Informal document GRSP-68-31-Rev.1
68th GRSP, 7-11 December 2020
Agenda item 7

Japan's comment on GRSP/2020/12
regarding the test procedure for the height of head restraints
in the case of vehicles having a low roof construction

Example of small car

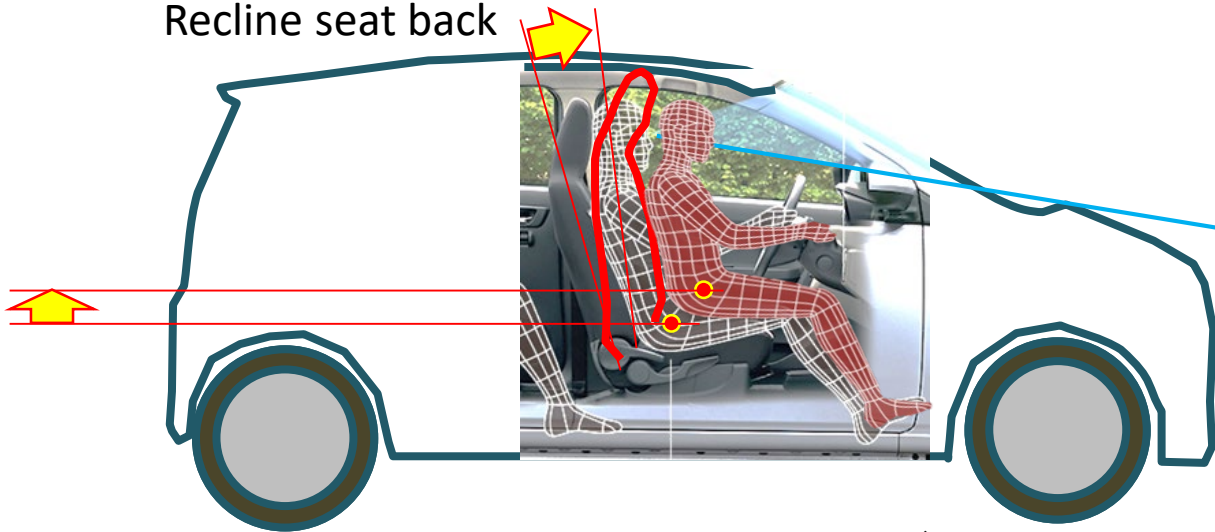
These two factors should be taken into consideration among GRSP experts.

- **Range of exempted vehicles**: This exemption could be applicable to a wide range of passenger cars (not only sport-type cars).
- **Safety risk on tall occupants**: Risk of whiplash injury to taller occupants could increase due to unadjustability and small height of head restraint.
